DE-24-087 DOE witness contradicts Eversource testimony.

DOE witness DeVergilio provides no evidence for his statements. He also contradicts statements made by Eversource:

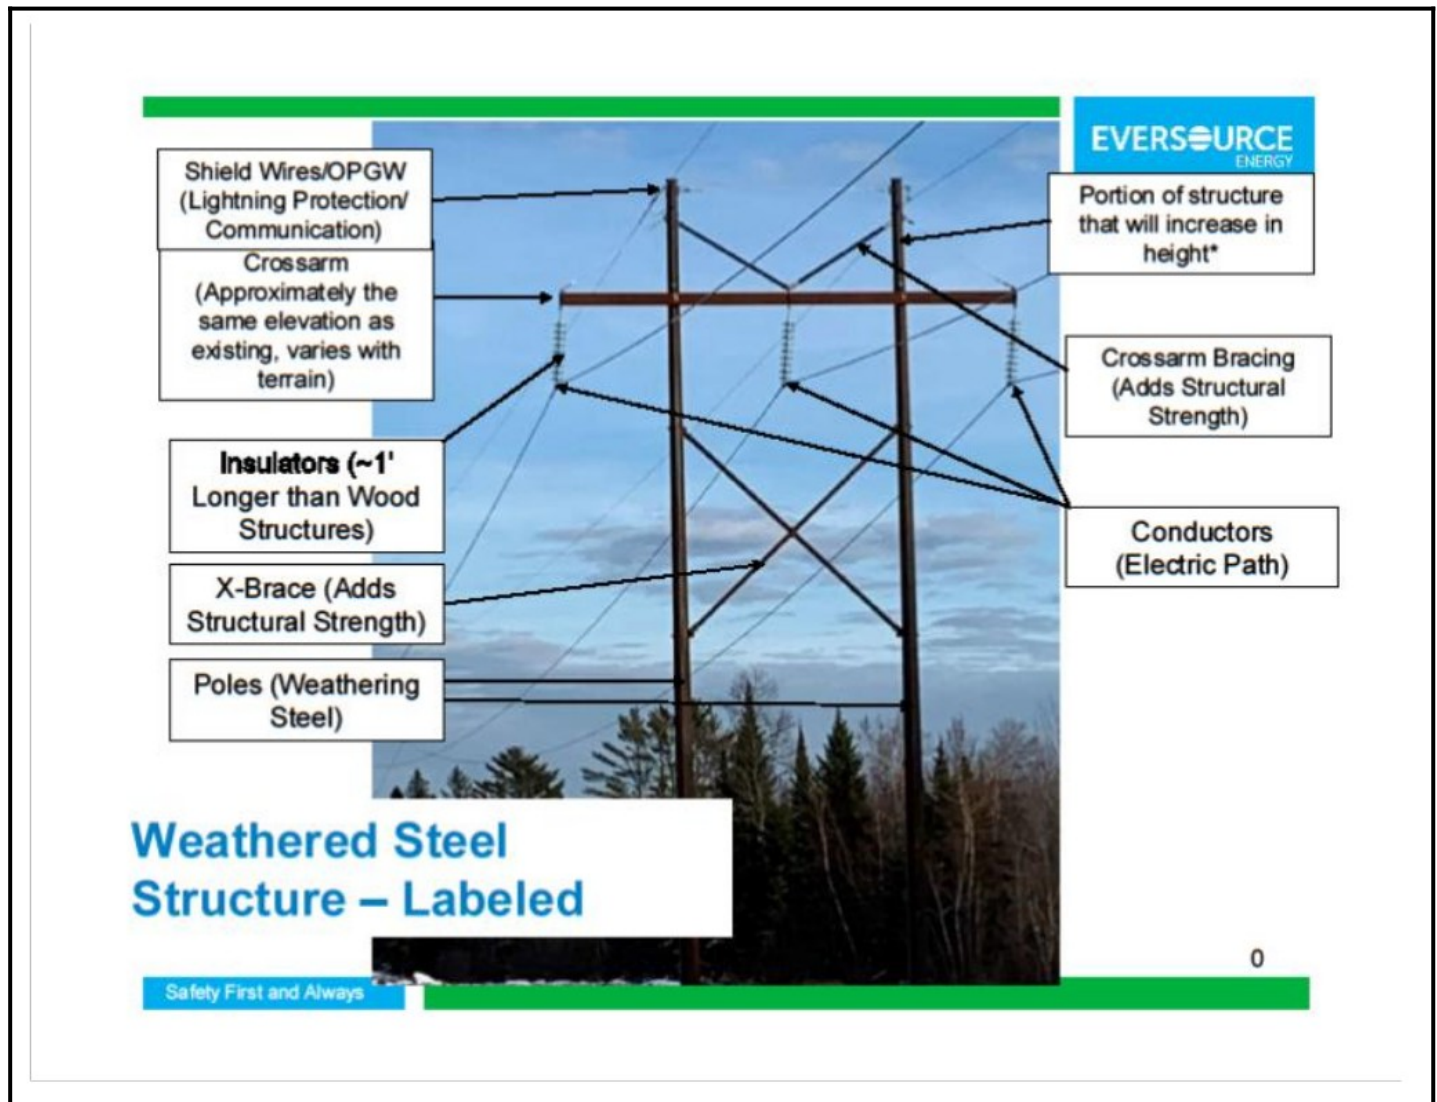
Eversource produced a diagram which shows the structure height increases occurring only above the cross-bar and insulators, and elsewhere claims that the OPGW requires a 15’

clearance from the conductors (compared to 10' required by the existing shield wire.) The diagram does not show structure heights increasing below the cross-bar and insulators, due to greater sag of the 1272 conductor:

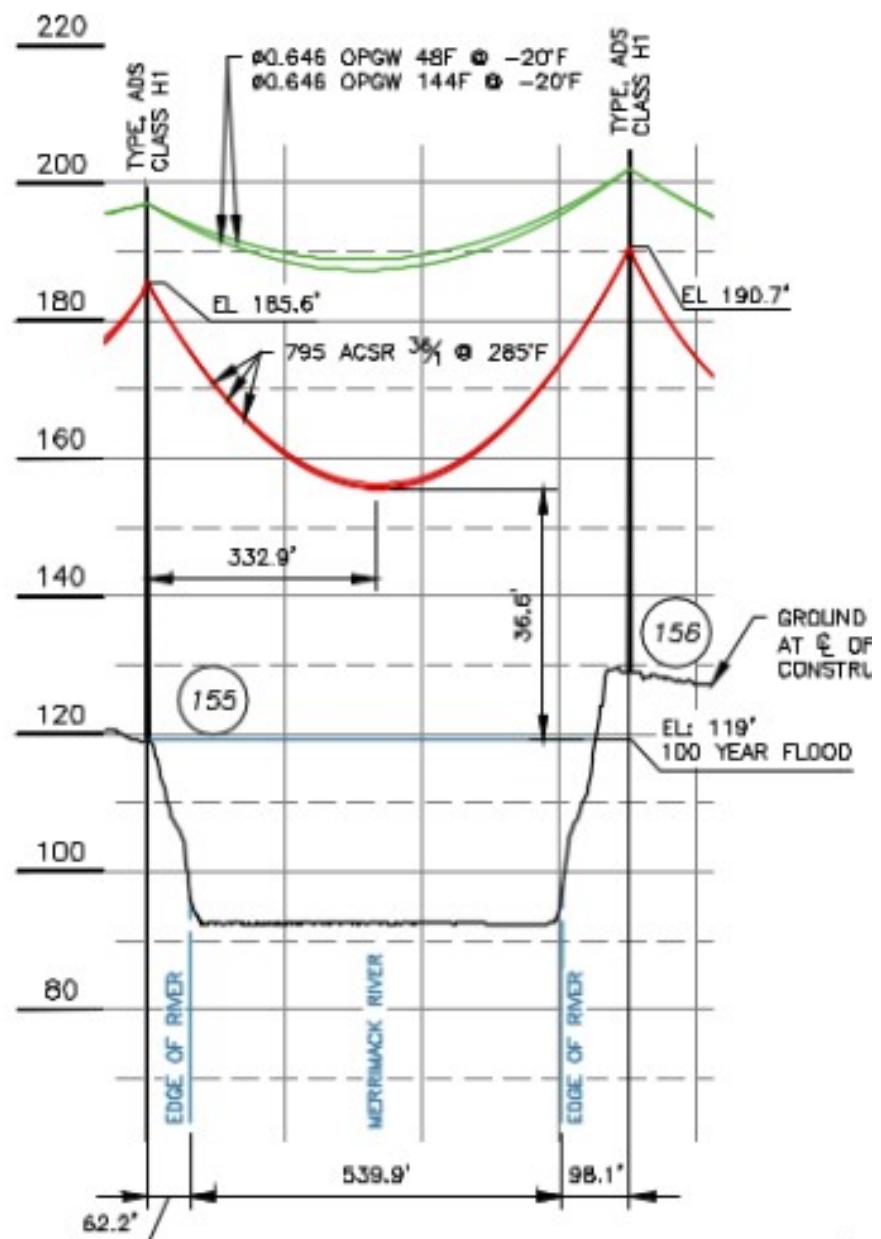
Below, 1272 ACSS
28' sag @ 688' span

Below, 795 ASCR
28' sag @ 700'
